<b>DESIGN REVIEW</b>		
Permit info: DSRFY2019-23		
Application Date: 10/25/2019		Rec'd by: CS/ES
FOR OFFICE USE ONLY

**River Pointe Phase 2**  
Garden City, Idaho # 2019-0040

CONCEPTUAL DESIGN  
OCTOBER 22ND, 2019

Good afternoon Chris. In light of the arborists report, we have updated our landscape plan to show full compliance with city ordinance. Please utilize these updated plans for the application, and let me know if you have any questions or concerns. Thank you.

**River Pointe Apartments (Existing)**

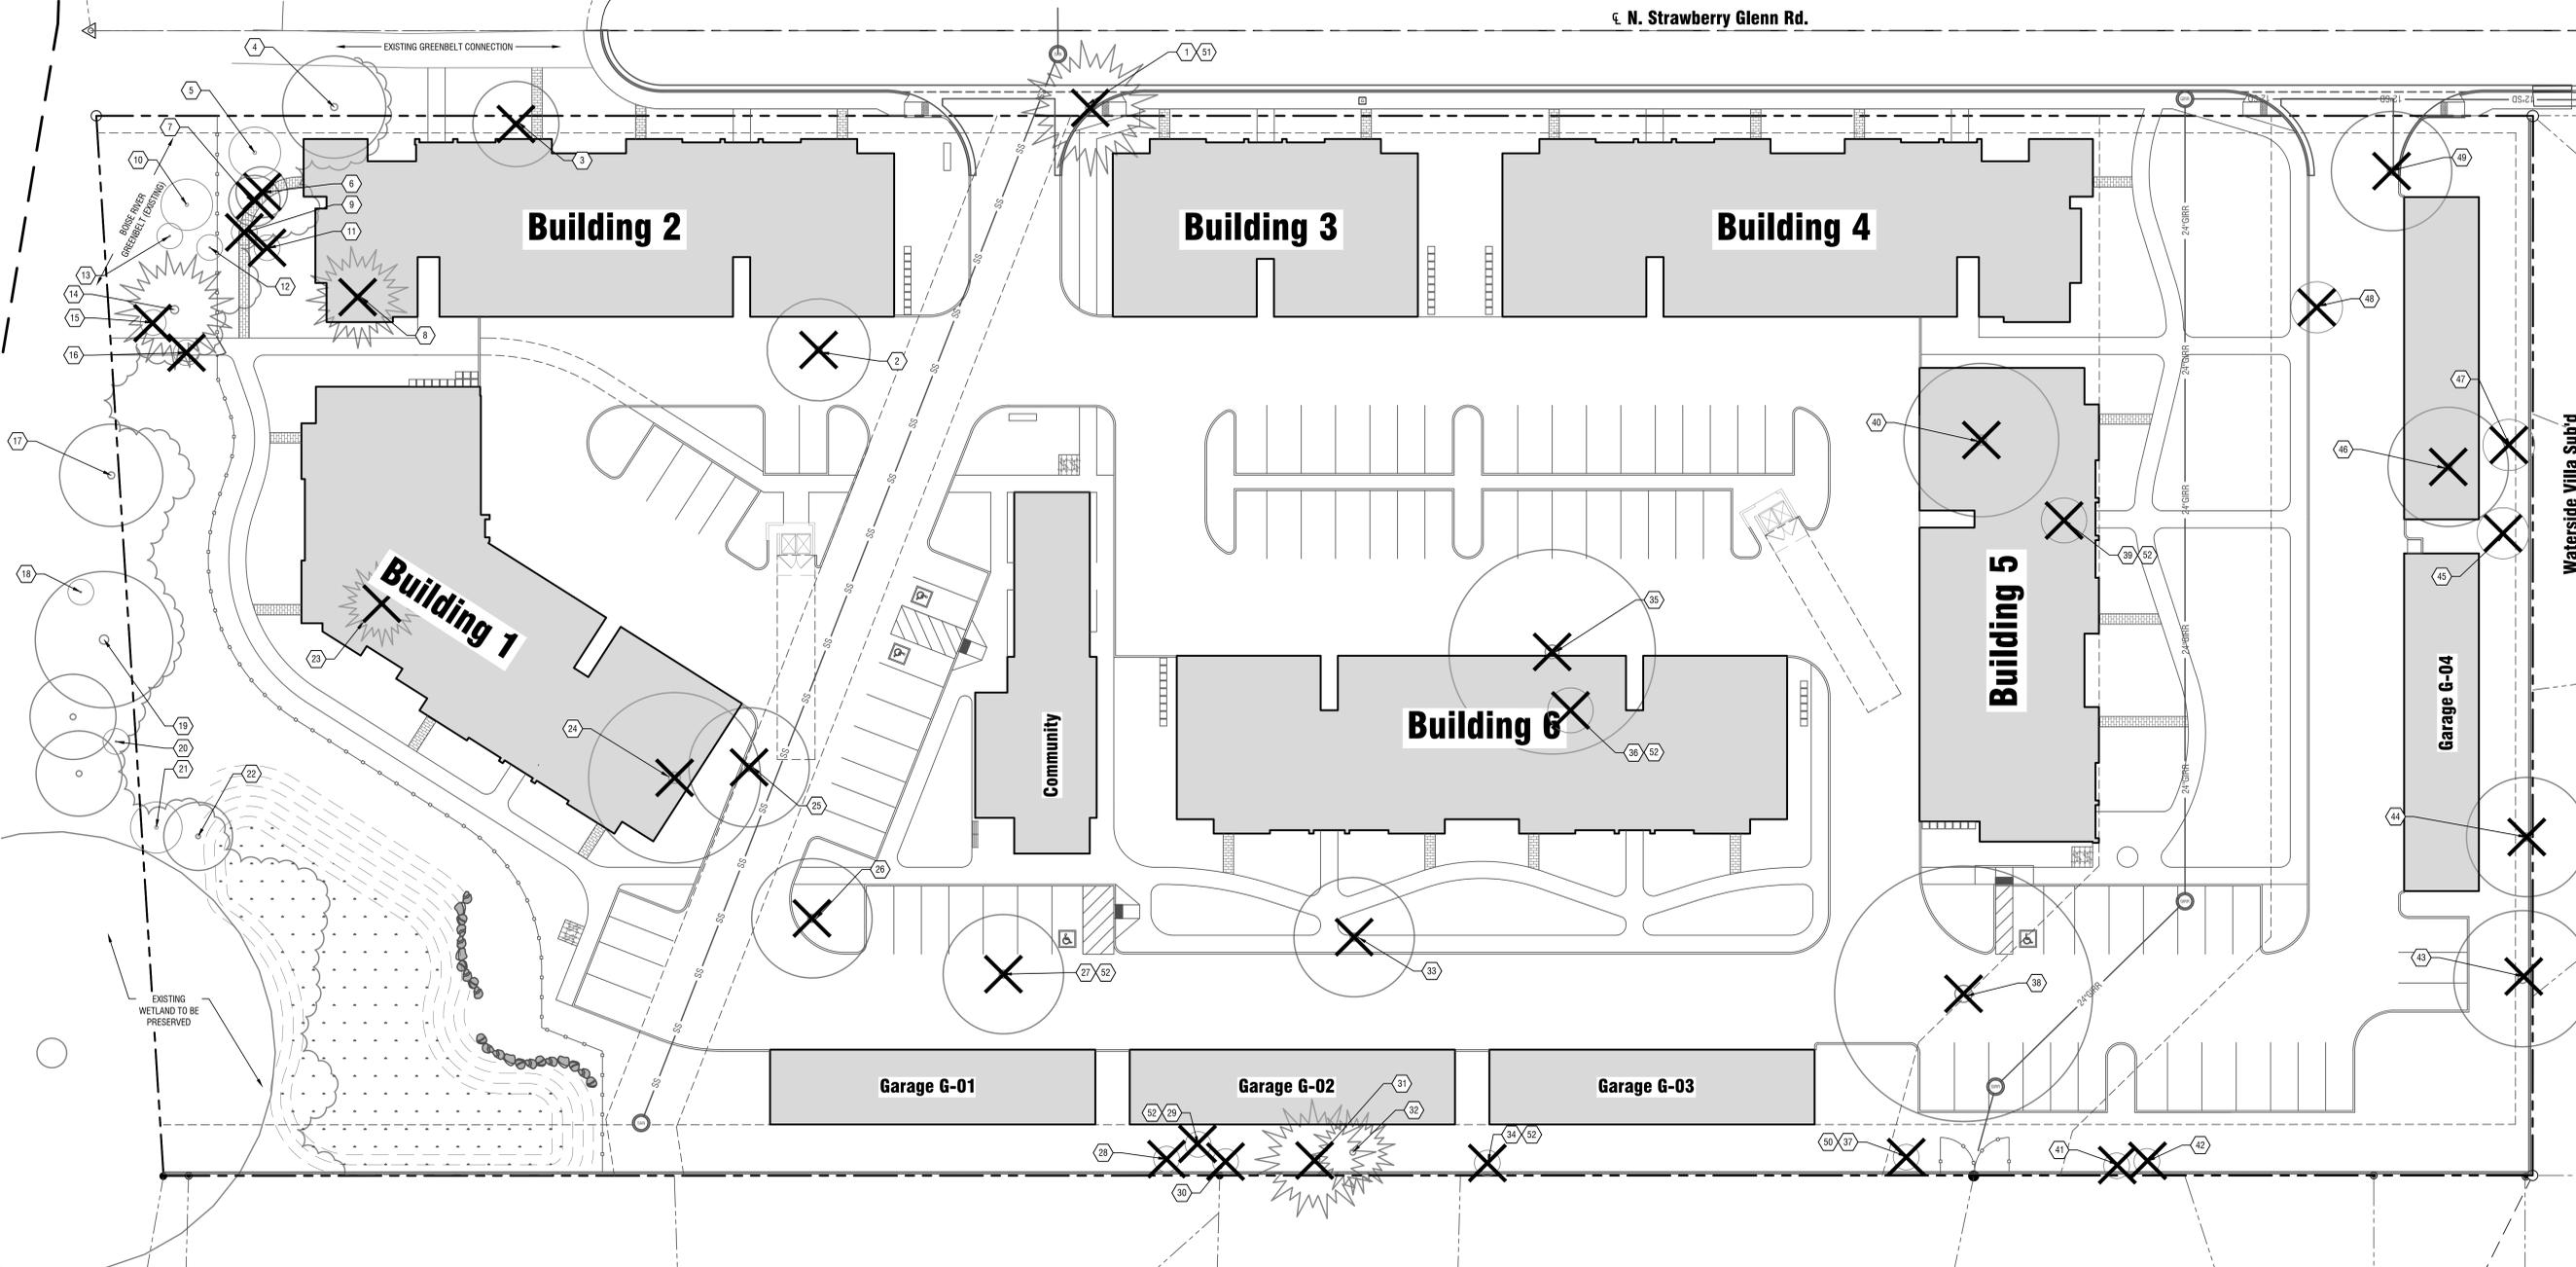
Sort of. Part of my role is to verify calculations for the Design Committee. There appears to be a discrepancy between the total number of 2" caliper trees for the entire project (85) and the total number of city code required trees (92 proposed at 2"). The 2" caliper city code required trees should be less than the total number of 2" caliper trees for the entire project, but the city code trees exceed the total number of 2" caliper trees for the entire project by 7.

To clarify, I meant 92 code required trees instead of 93. There appears to be a discrepancy of 7 caliper inches in the calculations.

I have one last clarification request. According to the tree mitigation calculation chart on sheet L000:

1. The project calculations regarding the number of trees on sheet L000 and sheet L100 do not

2. Please let me know how you got to 452 caliper inches. Are you planting trees adjacent or off site and if so, where? **See revised L000. This is based on the quantity of trees and caliper inches specified on the Plant Schedule on sheet L150. Tree caliper inches were increased from 2" to 3" for the onsite tree plantings to achieve the required tree mitigation. Additionally, (3) 3"-caliper trees were added to the site along the north edge of the southern drive aisle between the sidewalk and irrigation easement.**
3. Please provide an elevation or photo of the "Omega Secur" fence adjacent to the perimeter. Please include manufacturer specifications about material, color, and the like. **See attached pdf for information on the Omega Secur fencing.**

Hi Chris. I can't reach the landscape architect, but he did say that you were correct, in your initial observation. Before you clarified, he said "Chris' observations are correct. We increased the caliper size on some of the Code Required Trees (delta between 93 and 85) from 2"-caliper to 3"-caliper to

match. Specifically the tree quantities. Please review and correct the sheet or provide a statement with the correct quantities: See revised sheet L000 provided with additional notes to clarify. Chart references Trees required from Project Calculations L100. I think they may be confusing that with trees provided, The delta between trees provided and trees required are used in the tree mitigation calculations – i.e., 16 parking lot trees are required by 22 are provided, 6 of those are used toward tree mitigation calculations since they are in excess of what is required by code. There was an error, it previously stated 12 Street Frontage trees were required on the Tree Mitigation Calculation Chart, L000. Only 11 are required per L100. That was revised on the attached.

NOTE: CALIPER INCHES PROVIDE IS TOTAL TREE CALIPER INCHES PROVIDED MINUS CODE REQUIRED TREE CALIPER INCHES.
